GULF STATES UTILITIES COMPANY

February 2, 1984
RBG -16,933
File Code No. G9.5
G9.8.6.2

River Bend Station Units 1 and 2
Docket Nos. 50-458/50-459

Enclosed for your review are Gulf States Utilities Company responses to the open items identified in the Draft Safety Evaluation Report by the Auxiliary Systems Branch and responses to the request for additional information identified in part by Staff letters dated August 5, 1981 and December 31, 1981. This letter supplements docketed correspondences from Mr. Booker to Mr. Denton dated December 1, 1983 and December 30, 1983. Attachment 1 summarizes the open items and indicates changes to be made in the River Bend Station FSAR. Attachment 2 provides a brief discussion of each open item, the response and reference material for each item. Where indicated, these responses will be provided in a future amendment to the FSAR.

FIGURE 5.4-12

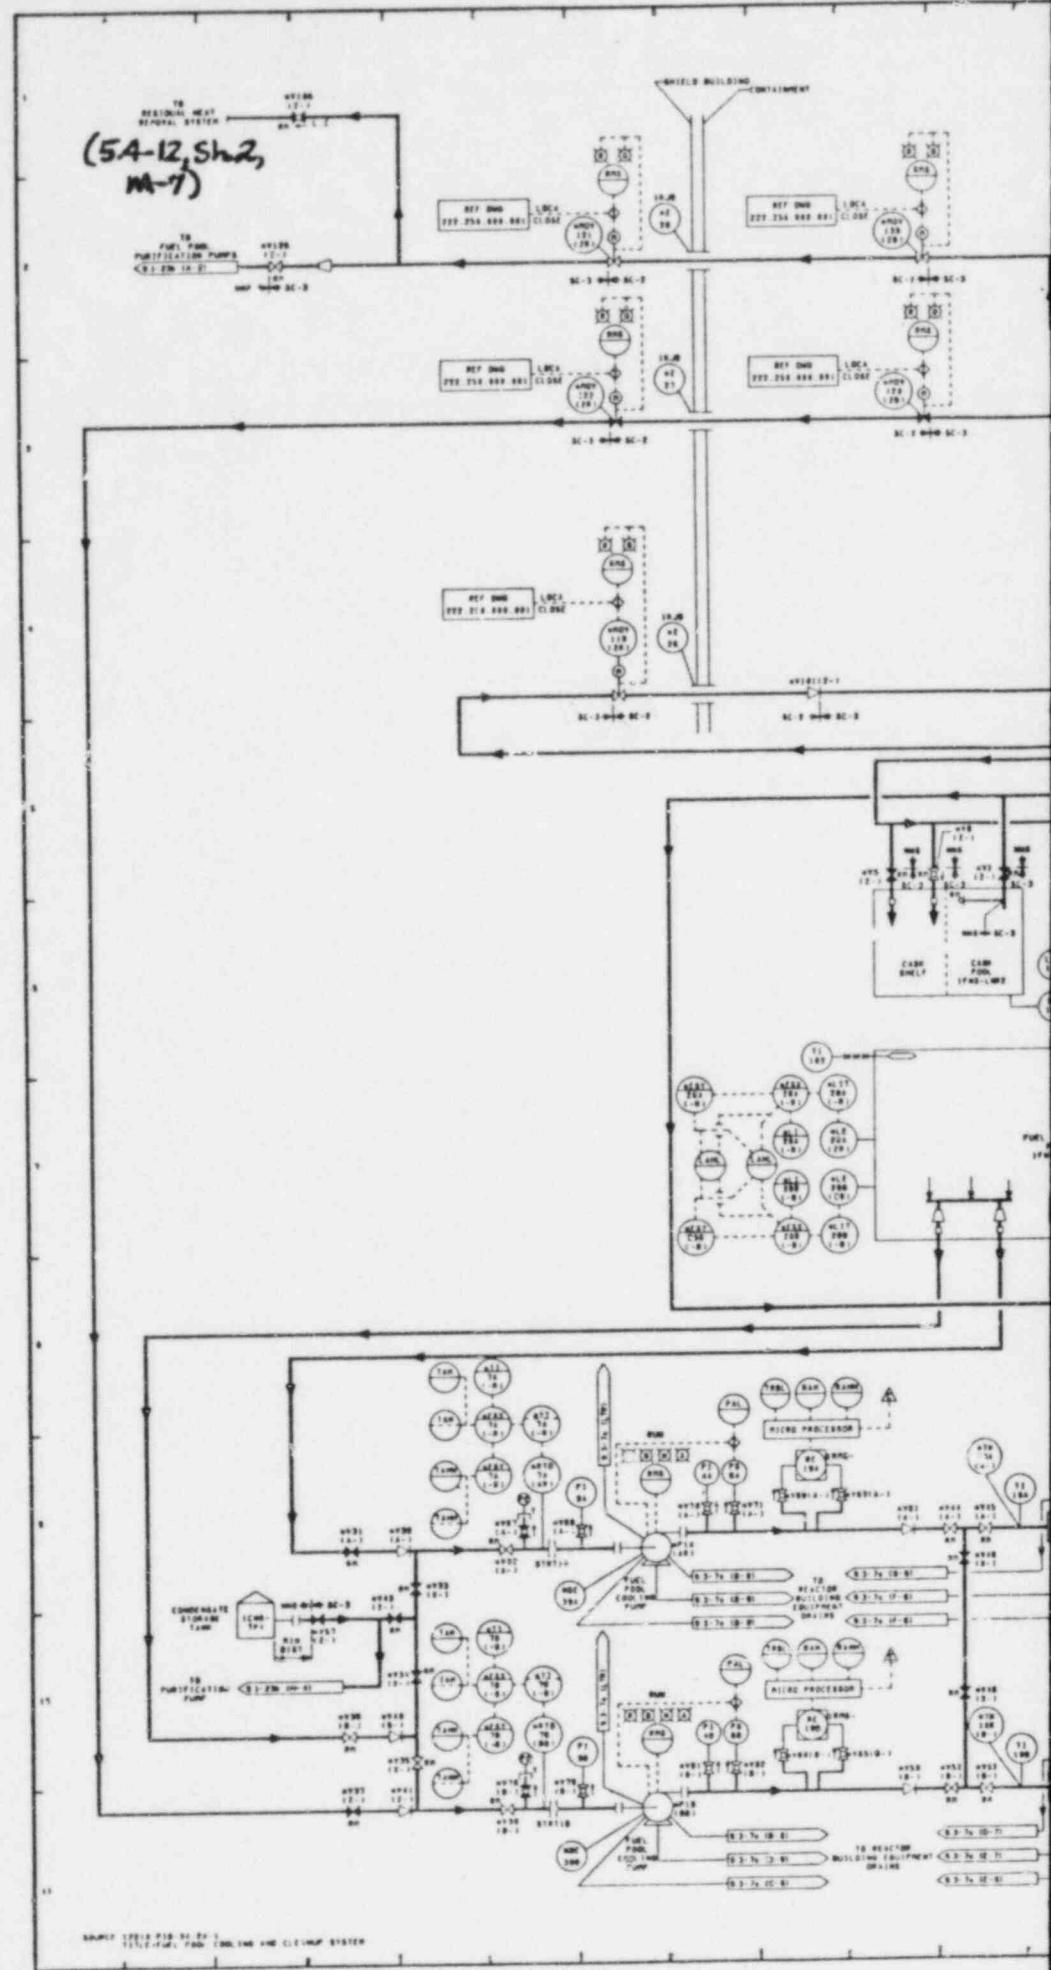
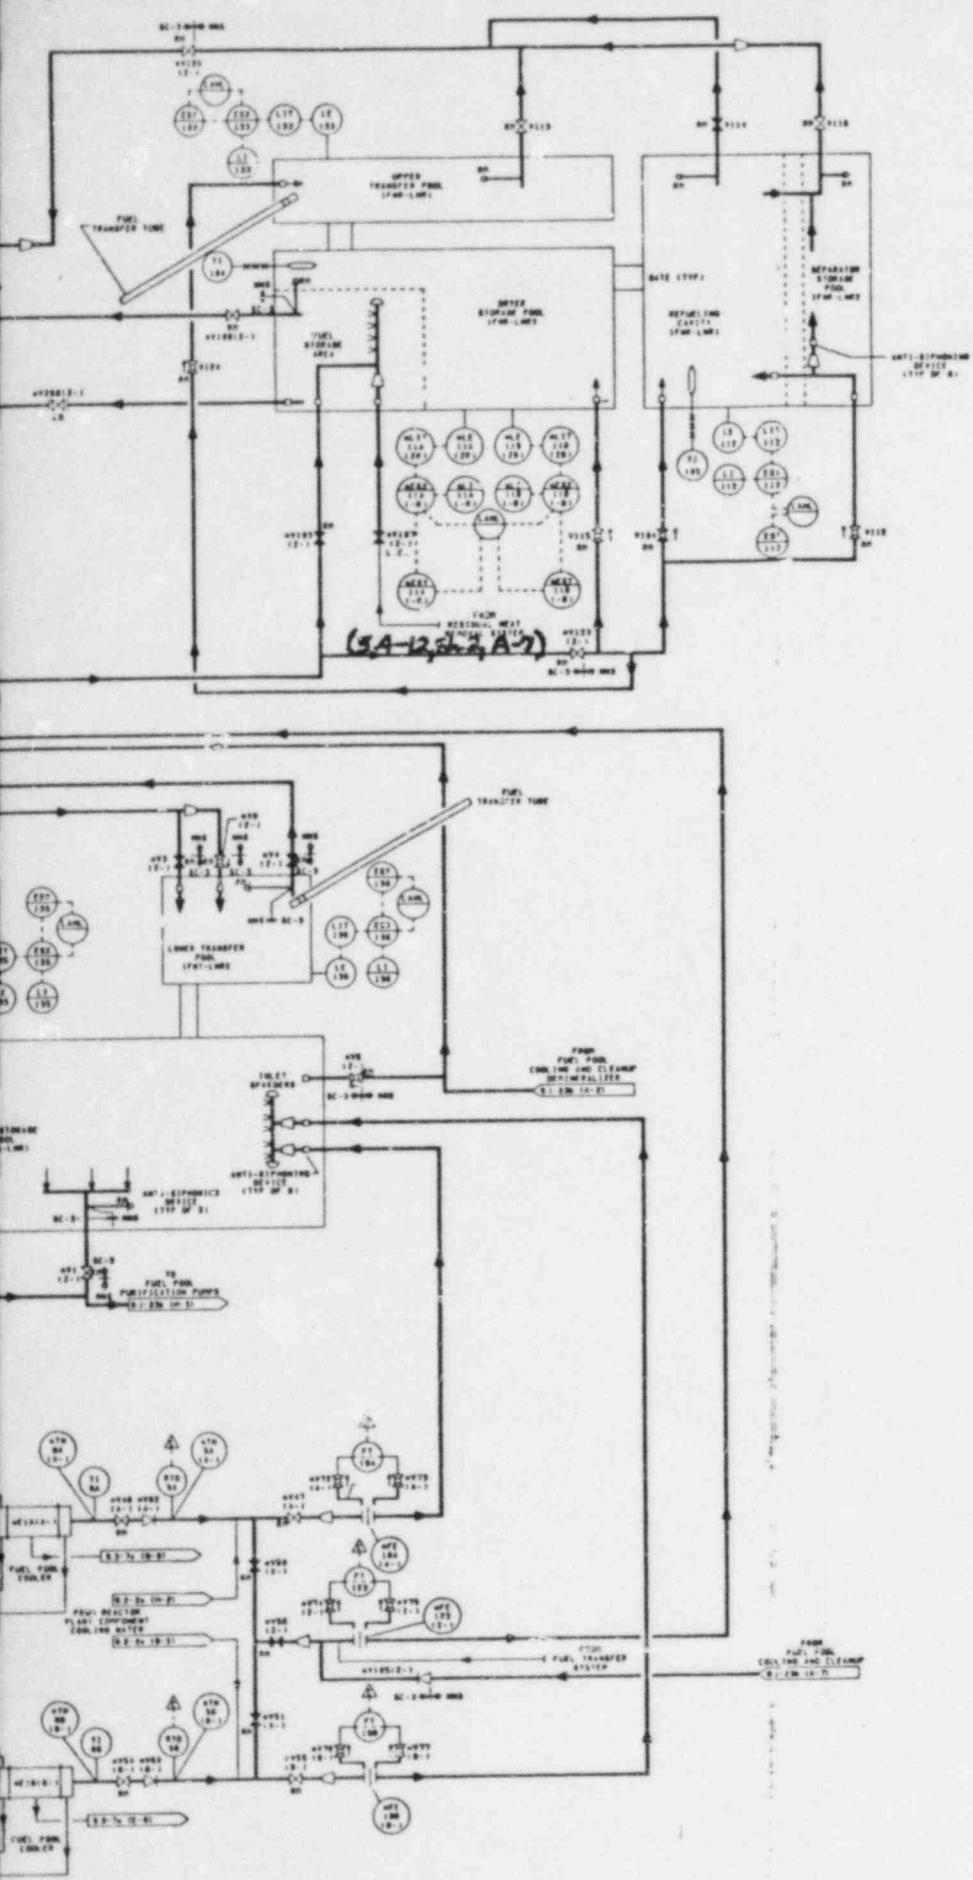
- 9c The applicant should show the interconnection of the RHR system with the fuel pool cooling system.

The interconnection is shown on revised FSAR Figures 9.1-23a and 5.4-12 sheet 2 of 3 (Enclosure 2)

ENCLOSURE 3

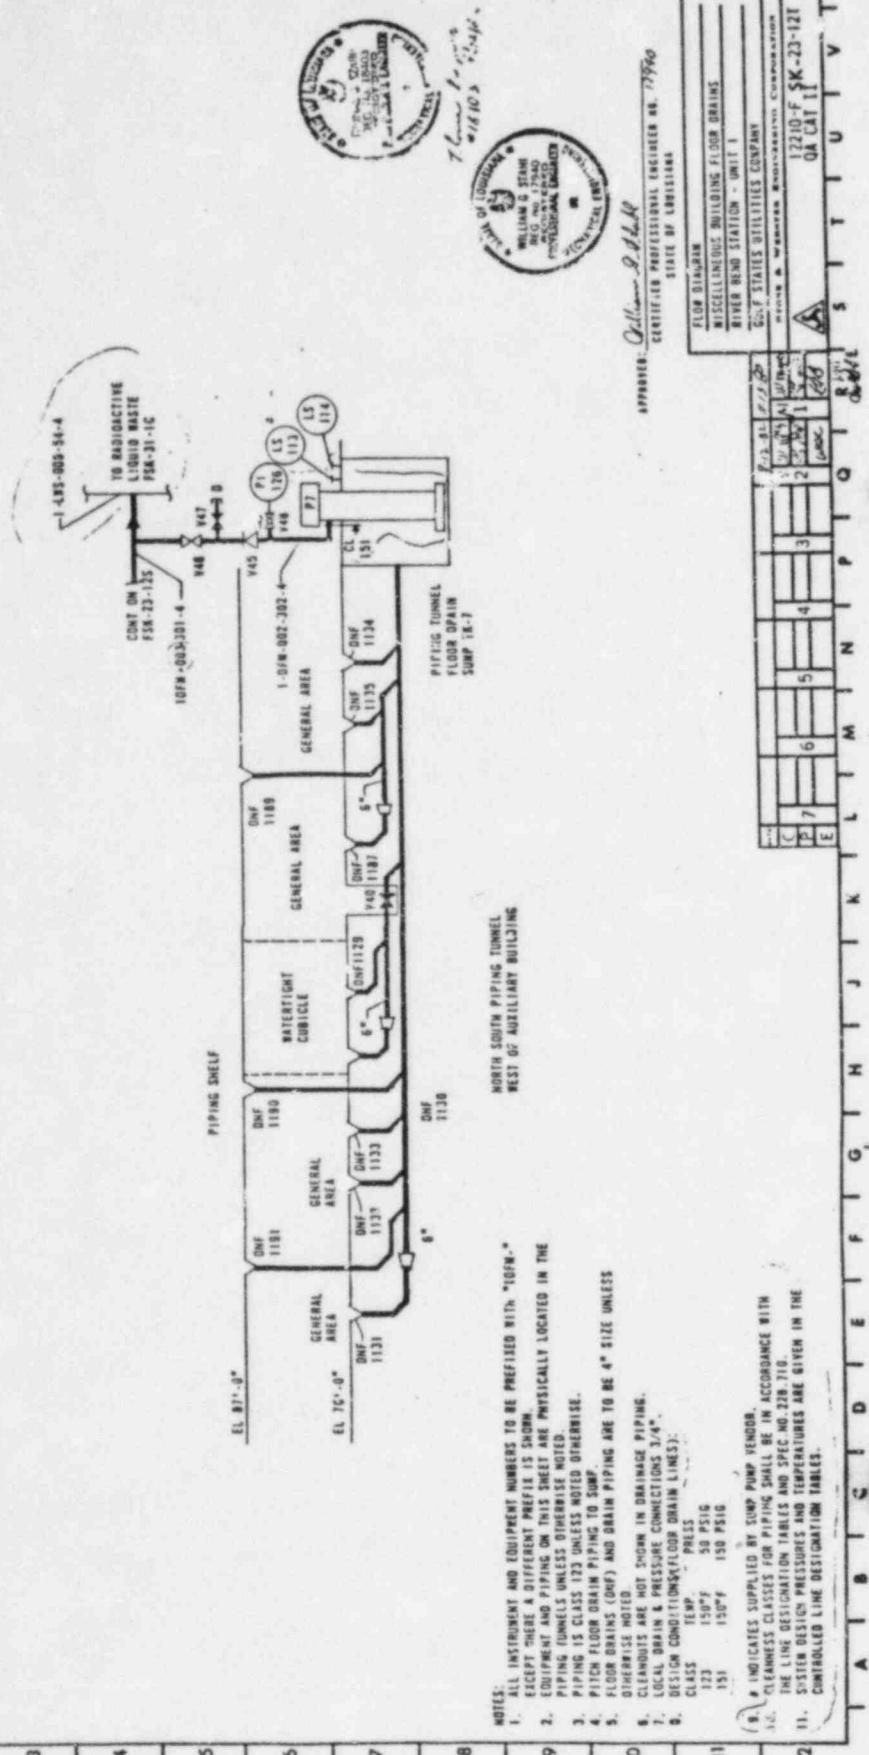
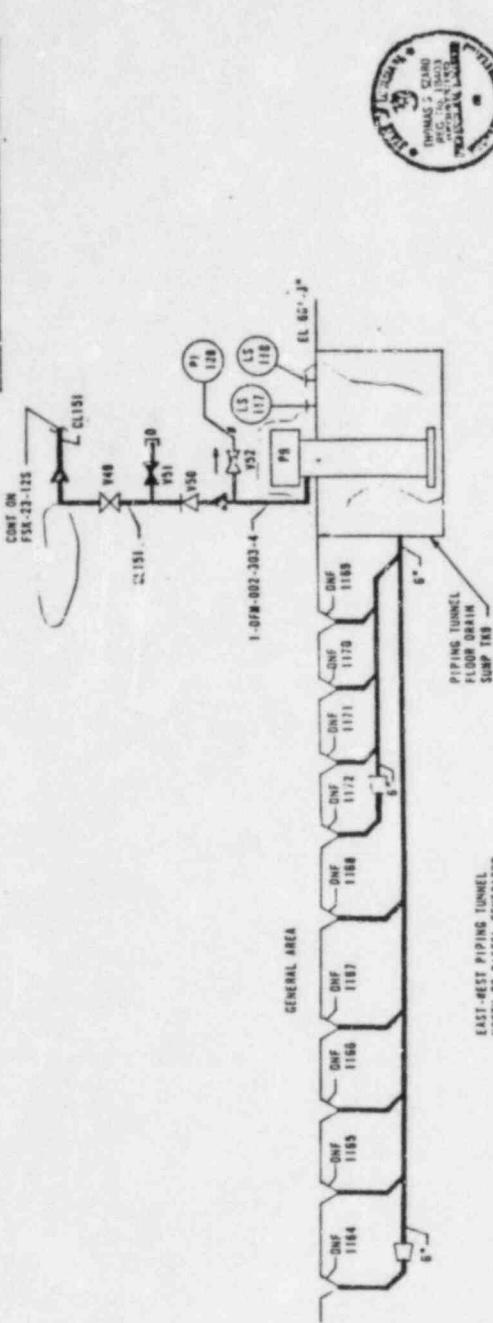
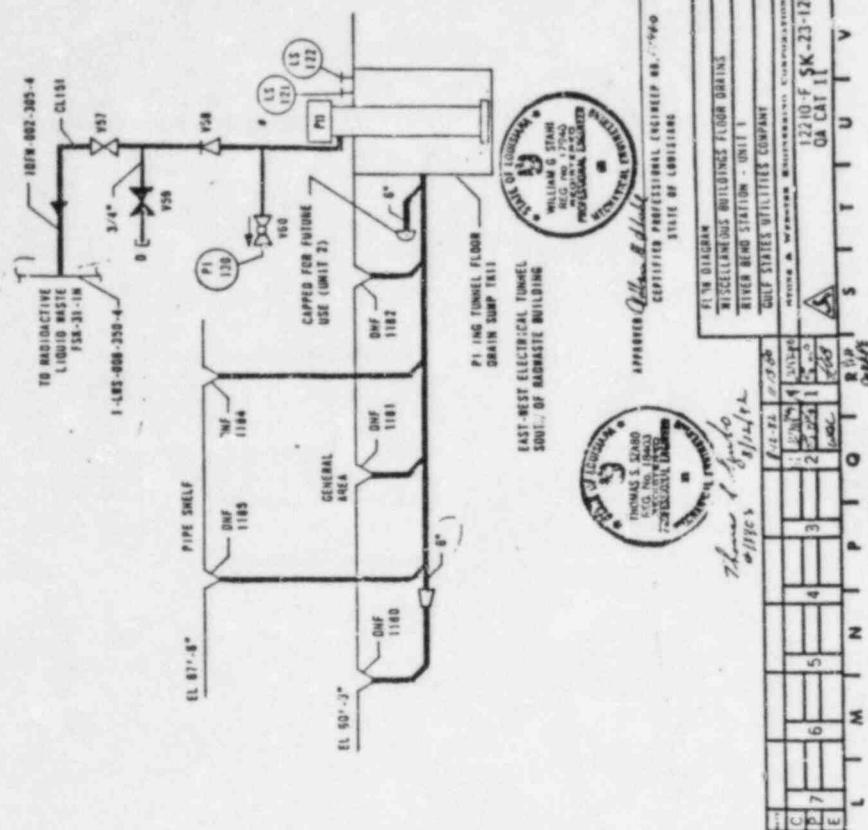
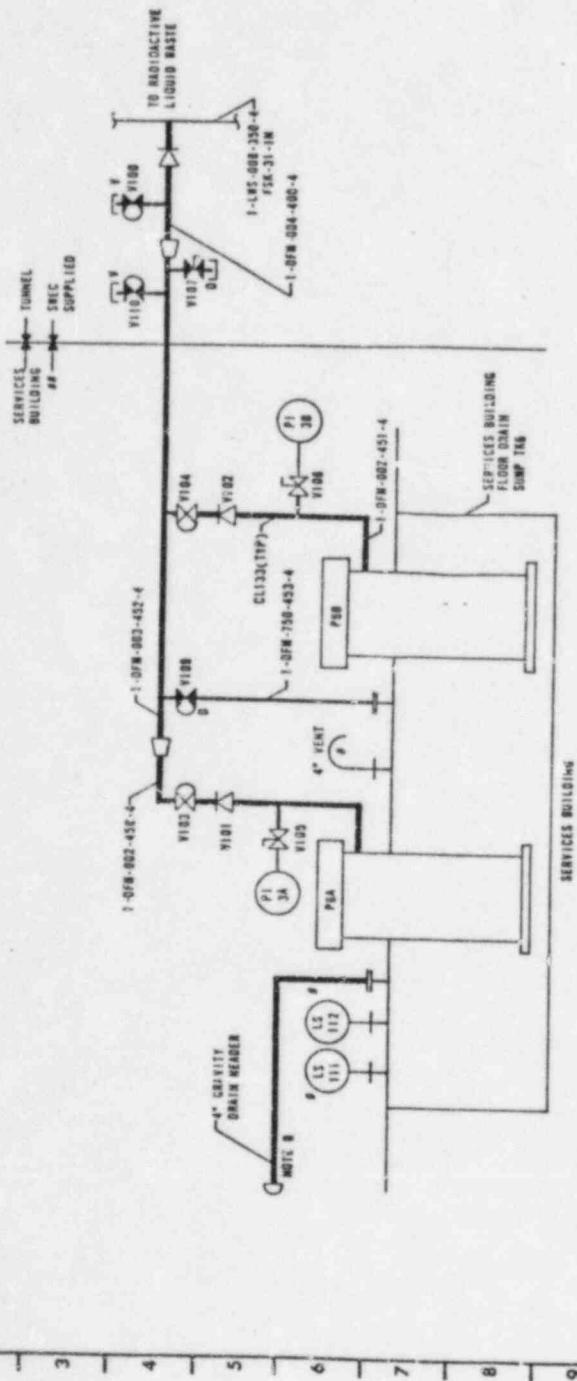
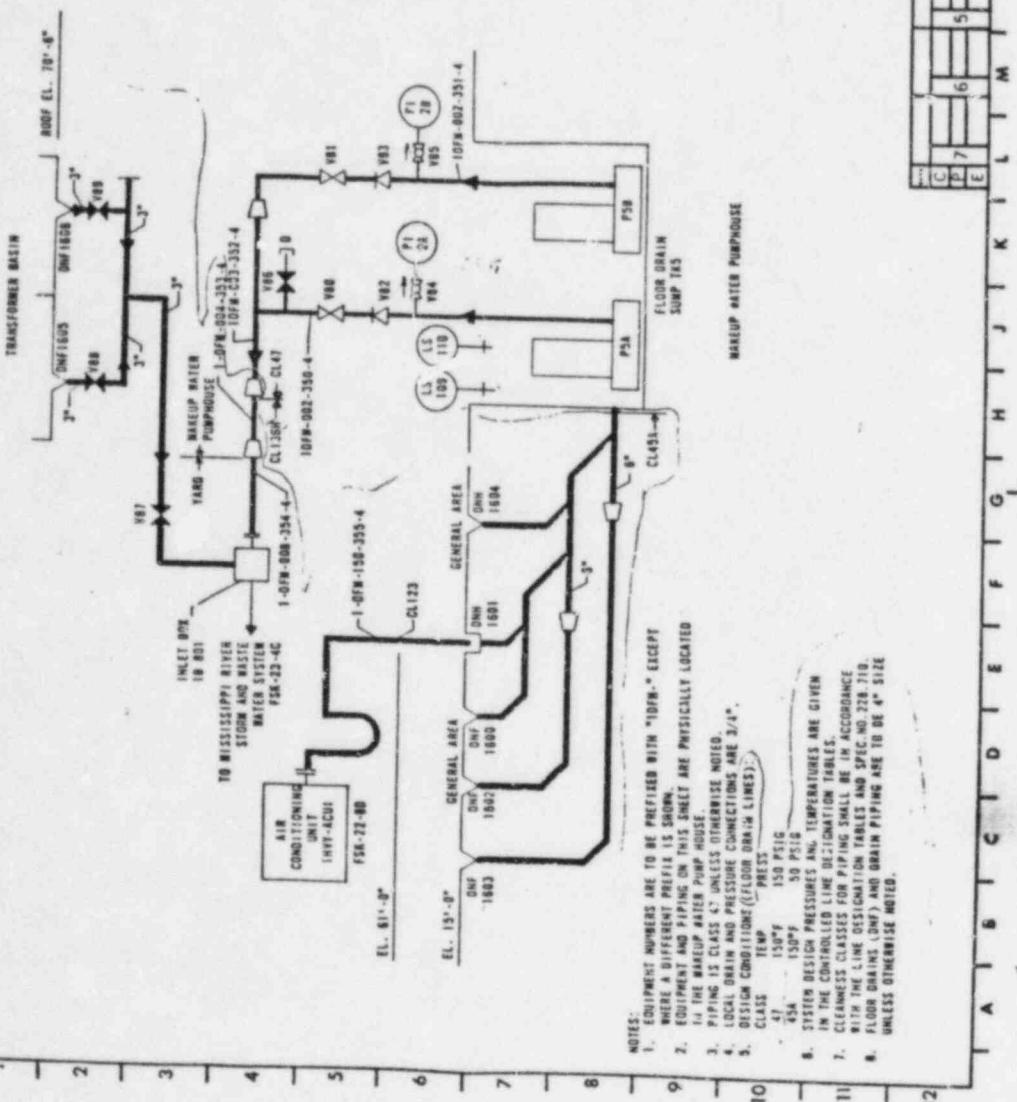
- 17a The applicant should provide drawings of the equipment and floor drainage systems.

Floor drainage drawings of the piping tunnel, services building, control building, electric tunnels, and the makeup water pumphouse are provided in Enclosure 3. Floor drainage drawings of the turbine building, reactor building, radwaste building, and fuel building are provided in Section 9.3. The drawings in Enclosure 3 will be incorporated into the FSAR in a future amendment.
